### IN THE DRAWINGS

## REMARKS

FIG. 10D

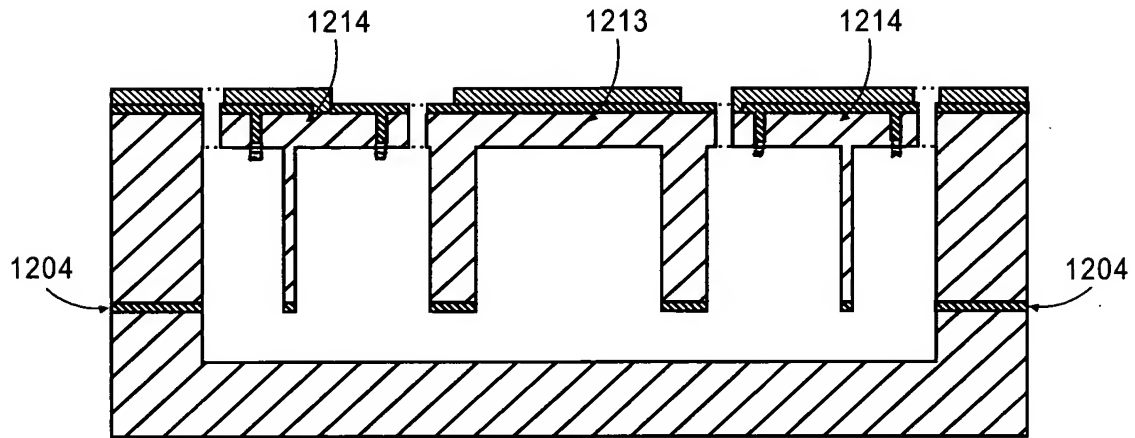
Annotated Sheets Showing Changes with respect to Figure 10D, 10E, and 12E of the drawings is provided with proposed change indicated in red ink. Corresponding Replacement Sheets are also enclosed. Applicants submit that the drawing as amended does not add new matter given that support is found in the originally filed drawings and in the specification at page 35, lines 1-5.

Figures 10D, 10E, and 12E have been amended to conform the formal drawings to the originally-filed drawings. Support for the corrections is found in originally filed Figures 10D, 10E, and 12E of the drawings.
